ADDENDUM #1

Re: Maine Department of Agriculture, Conservation, and Forestry
Bureau of Parks and Lands
Camden Hills State Park Water System Upgrades
Camden, Maine

From: Haley Ward, Inc.
One Merchants Plaza, Suite 701
Bangor, ME 04401

Owner Project No:
BGS Project No: 3464
Project No: 14641.001

NOTE: SEE SHEET S-102 FOR CONCRETE PAD AND UNISTRUT BRACING DETAILS.
TANK PIPING SCHEMATIC
N.T.S.

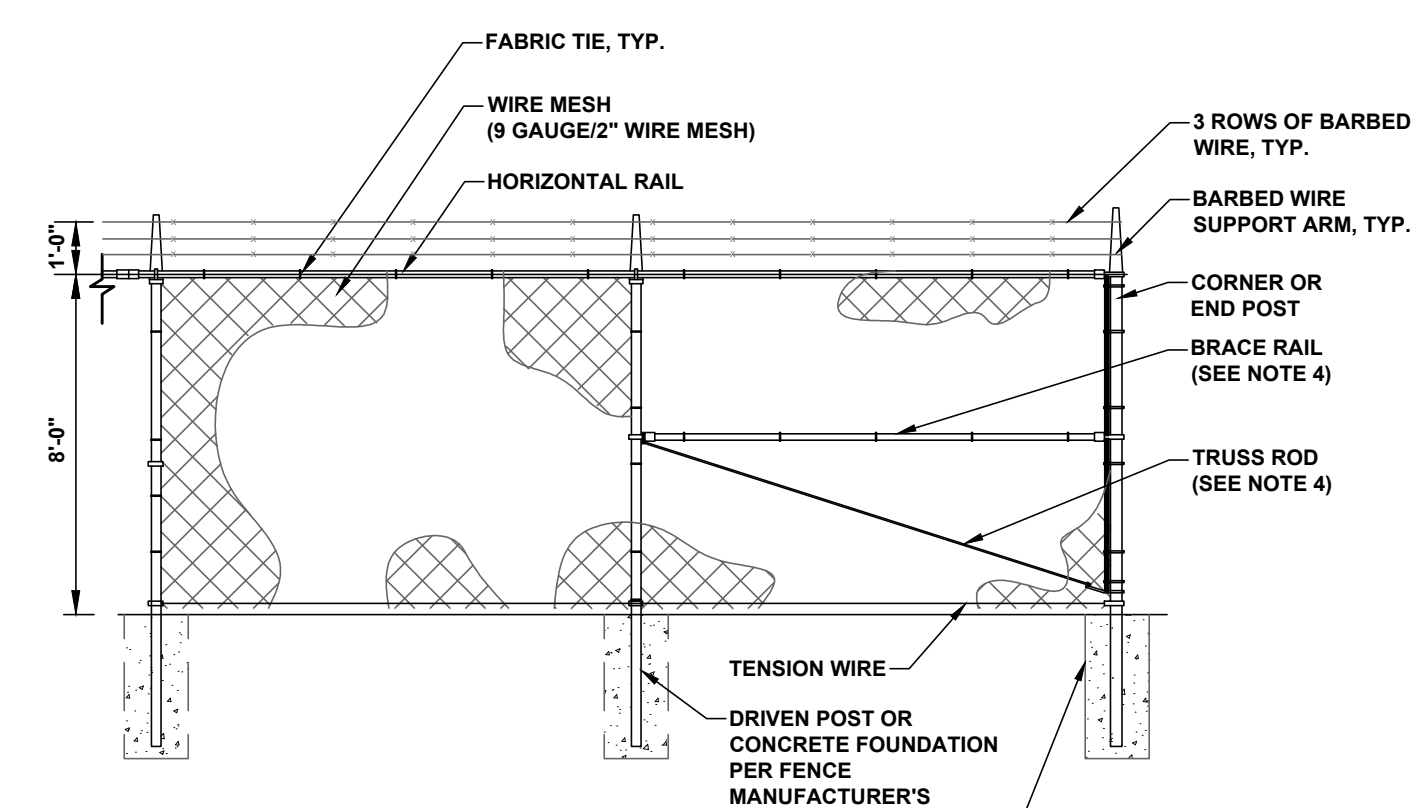
Remove “Unistrut Bracing Detail” from Drawing Sheet C502.

Revise Note on “Tank Piping Schematic” as shown on C502.

WATER AND ELECTRICAL LINES TO TANK TRENCH DETAIL
N.T.S.

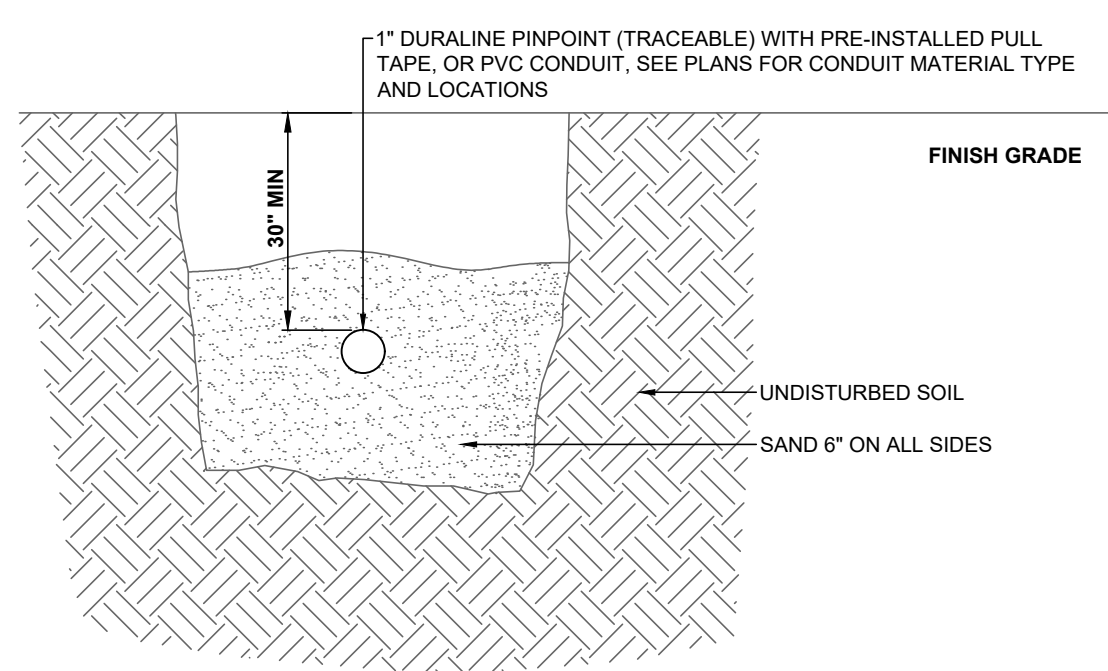
Q: Can you provide a detail for the typical water and conduit trench to/from the proposed water tanks?

Add Detail “Water and Electrical Lines to Tank Trench Detail.

A: Yes. Please see the Water and Electrical Lines to Tank Trench Detail on Drawing Sheet C502 per this Addendum.

WATER TANK CONCRETE PAD
SCALE: 3/8" = 1'-0"

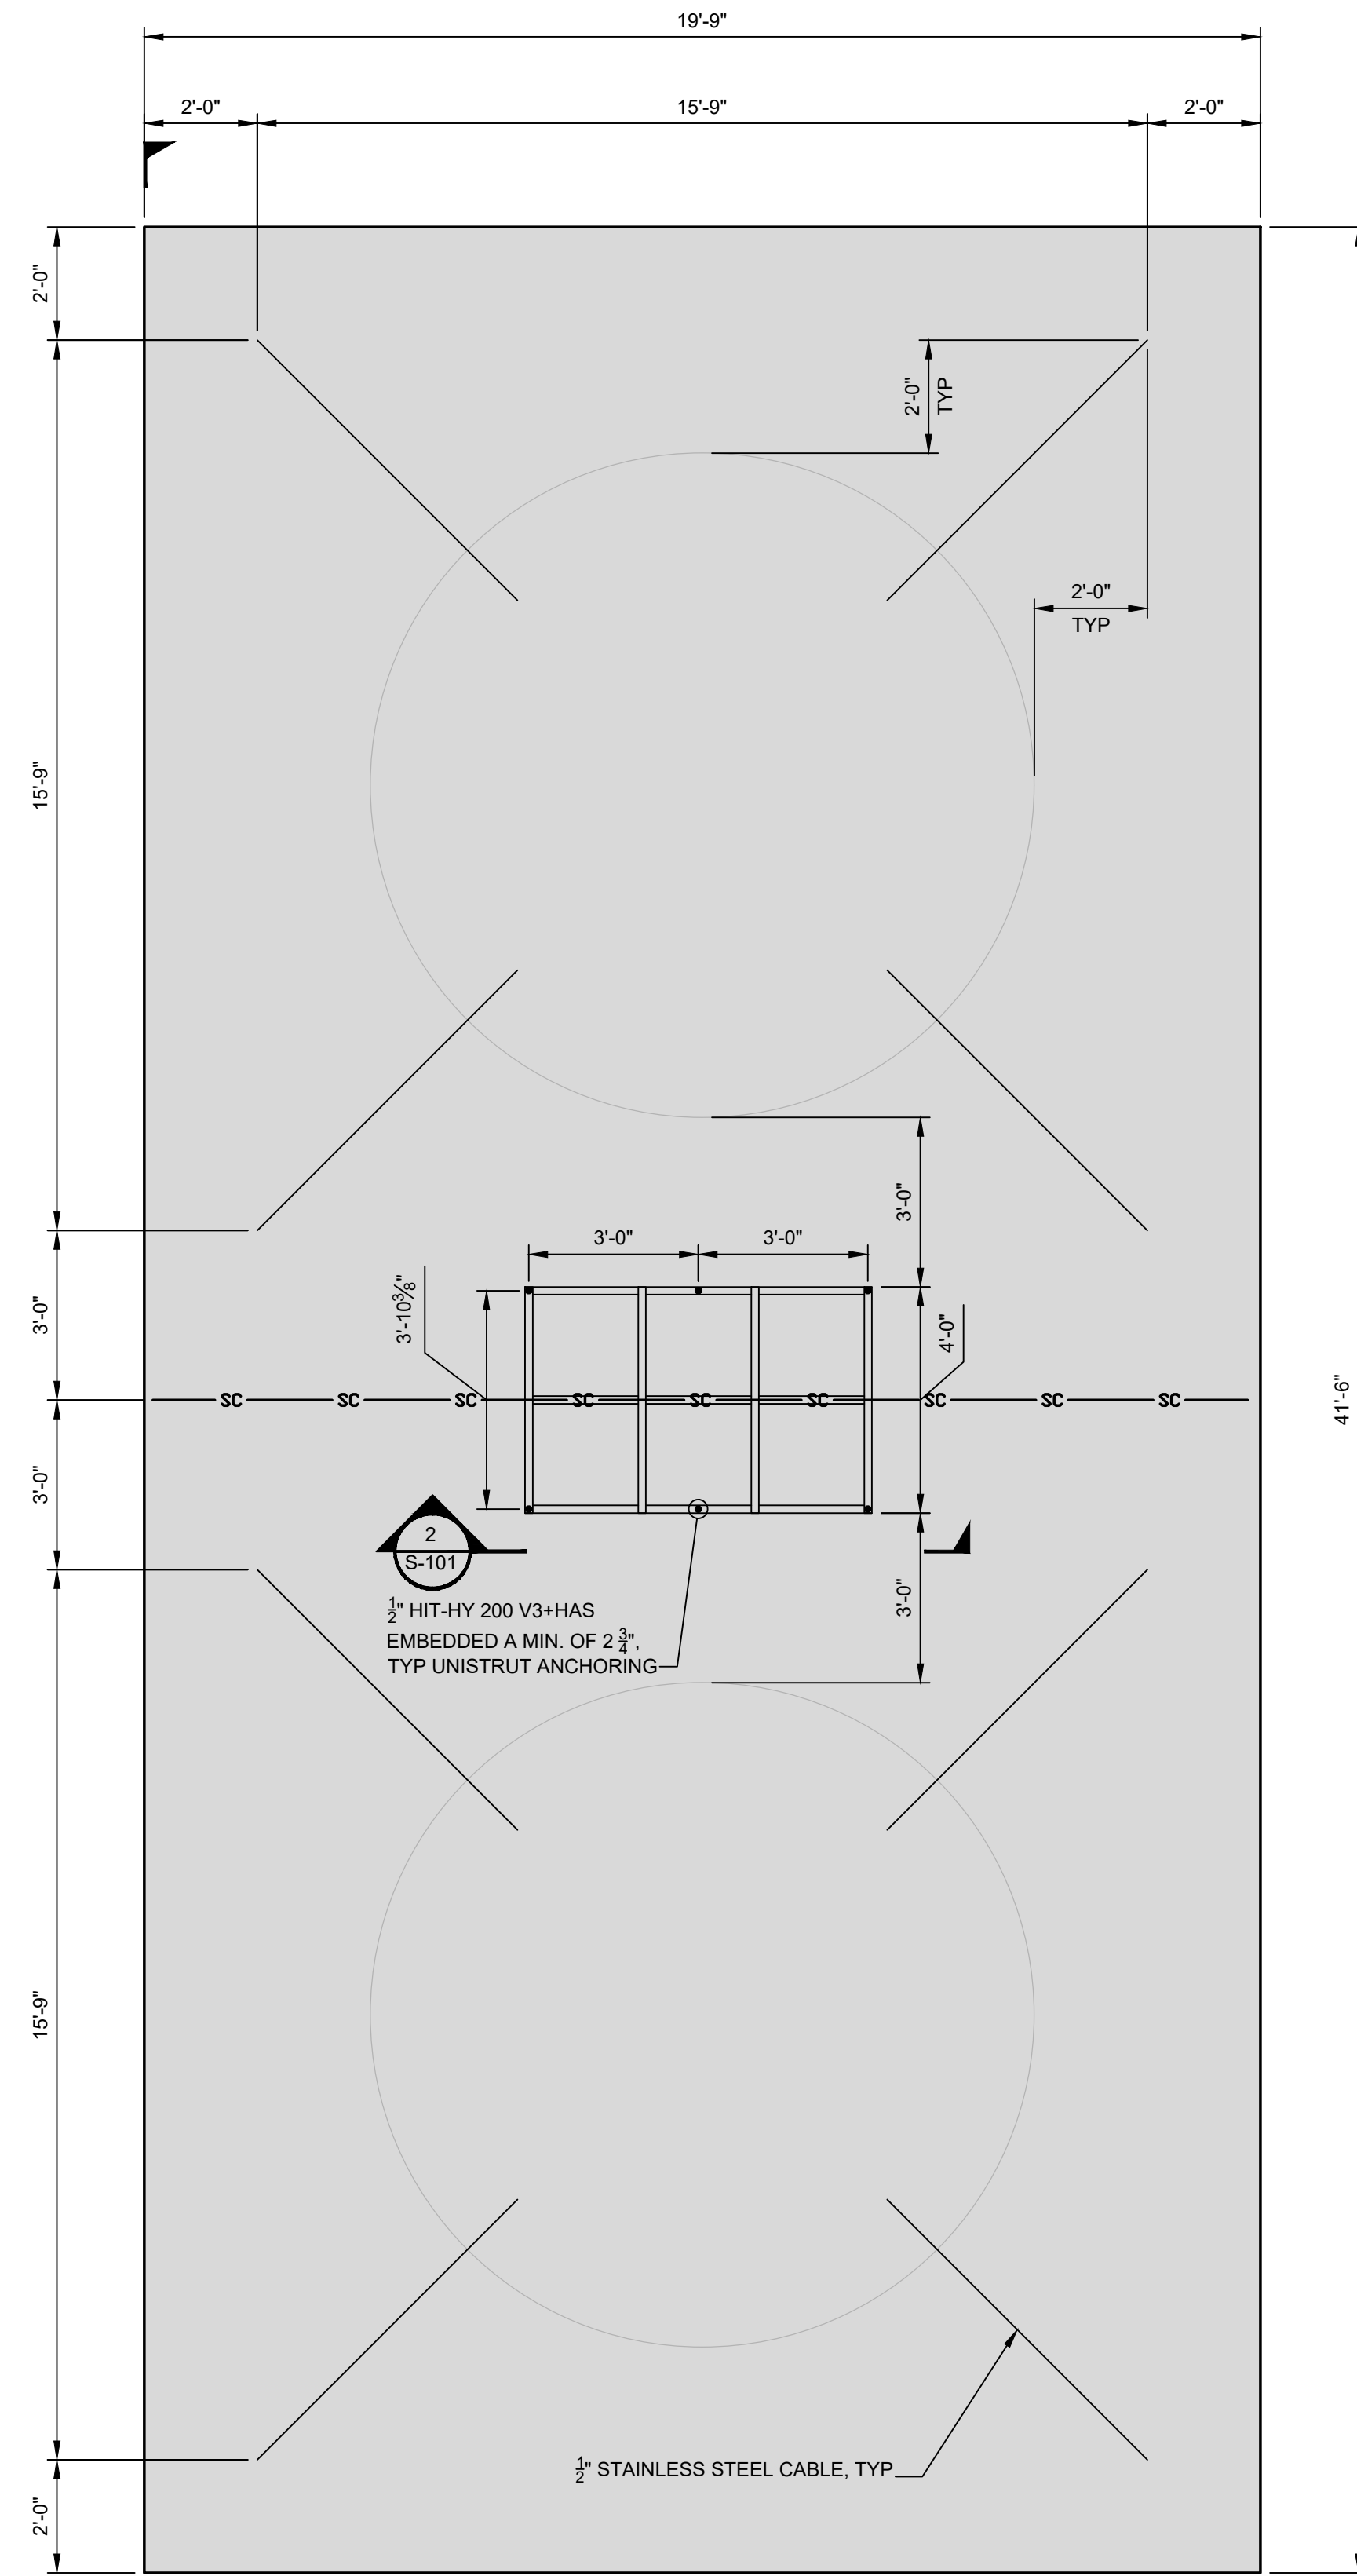
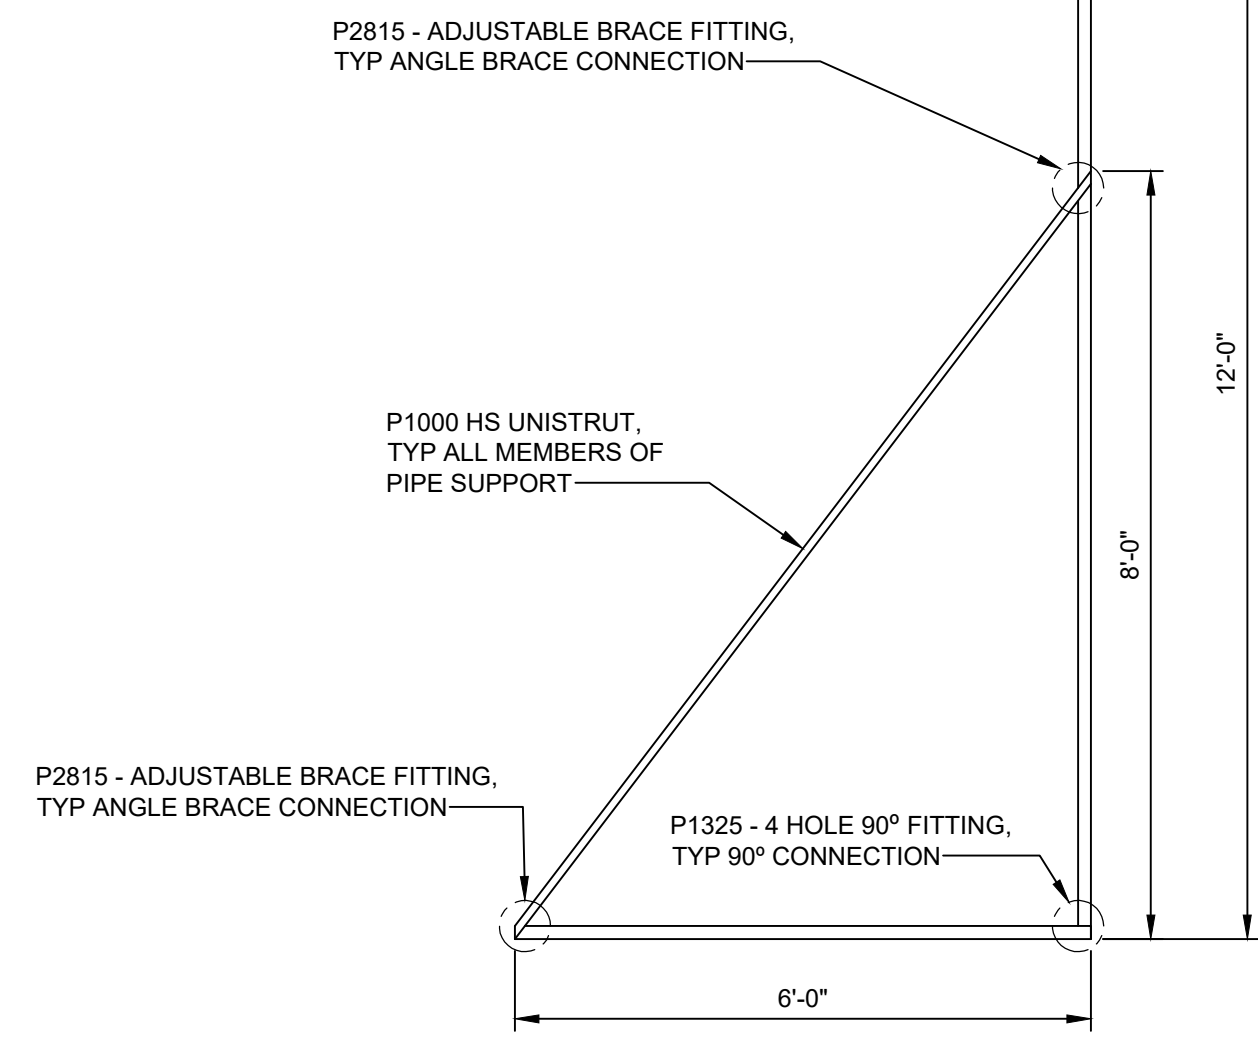
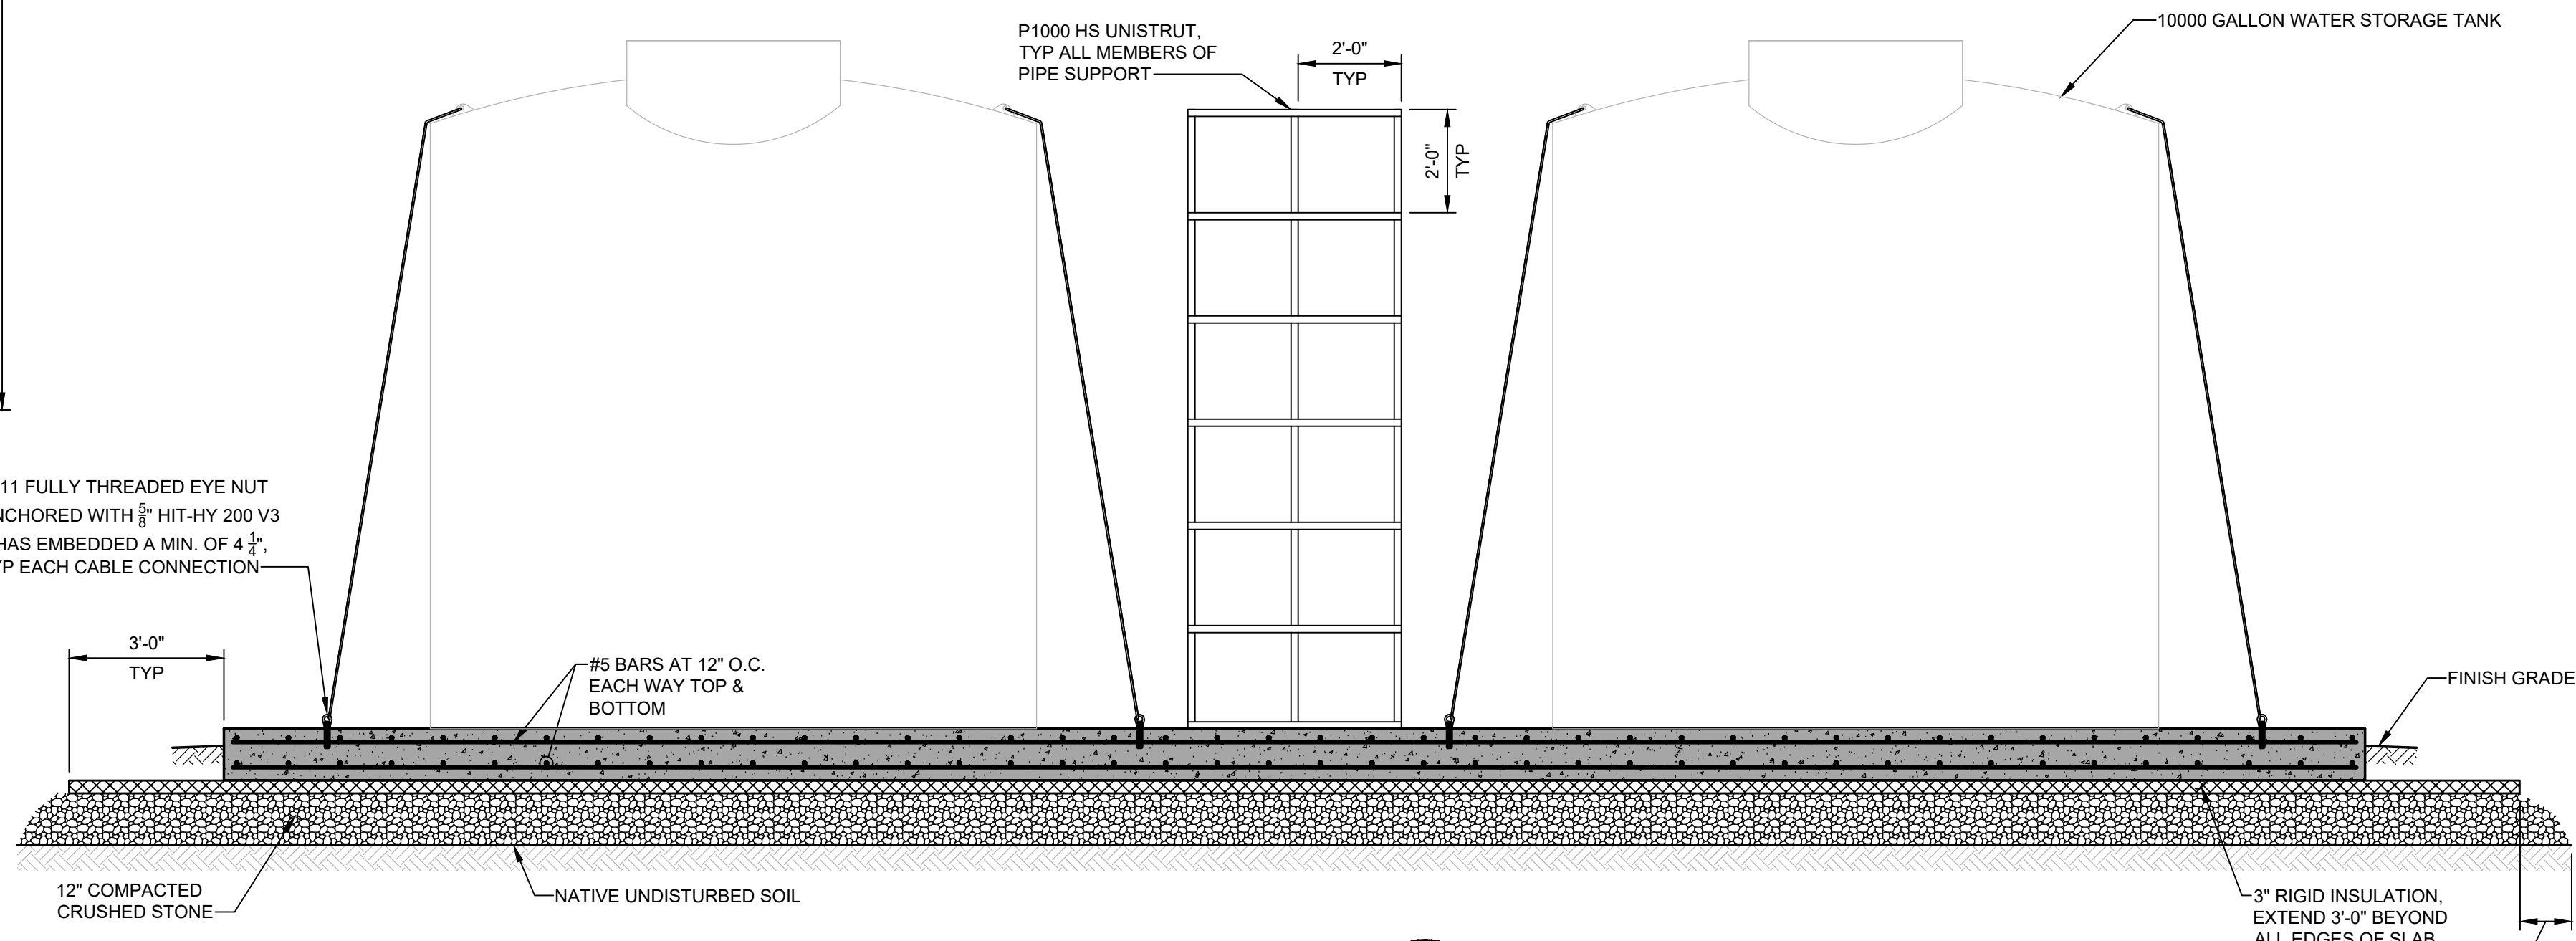
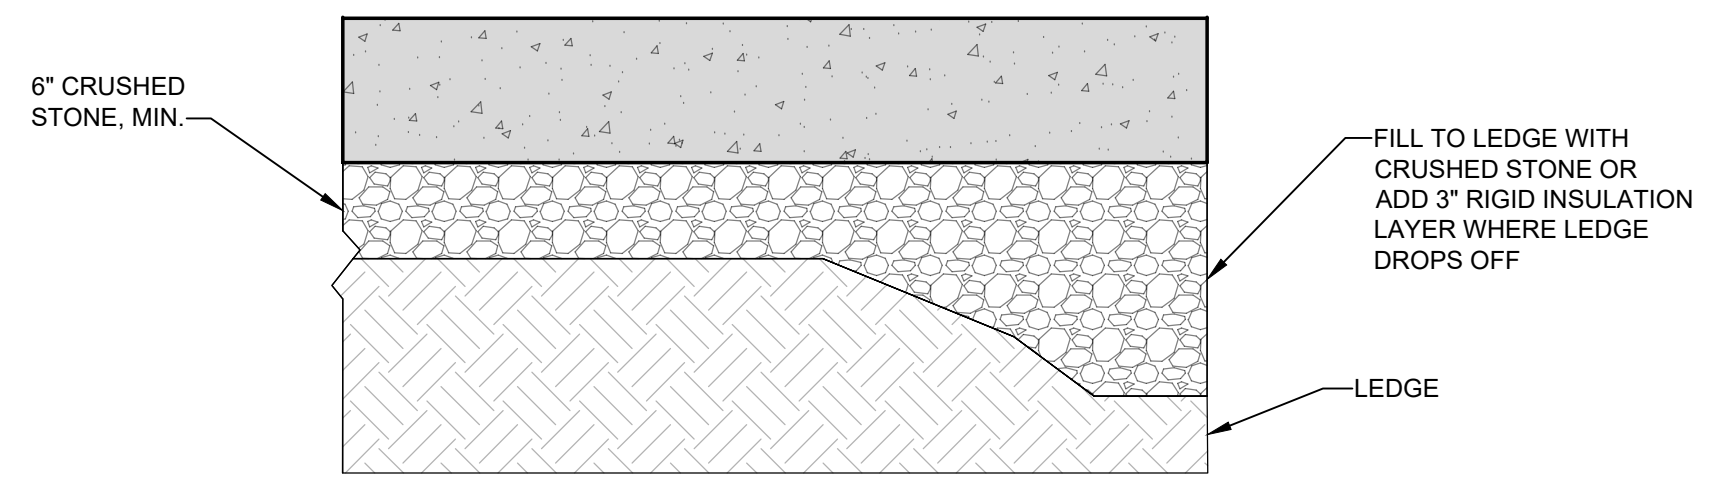
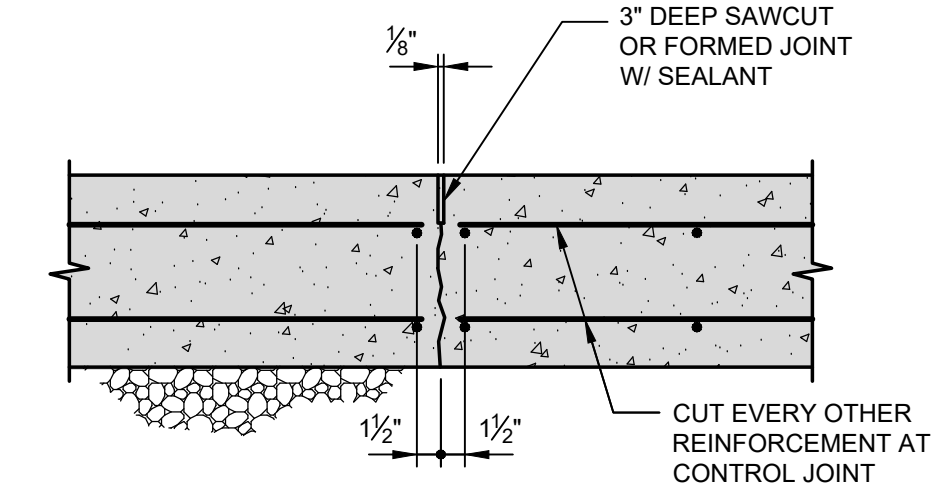
Q: Will the proposed tanks be set on a concrete slab? Can you provide a detail for the concrete slab underneath the proposed tanks?

Drawing Sheet S-102 has been added to the Contract Documents.

A: Yes. Please see Drawing Sheet S-102, which has been added to the Contract Documents per this Addendum.
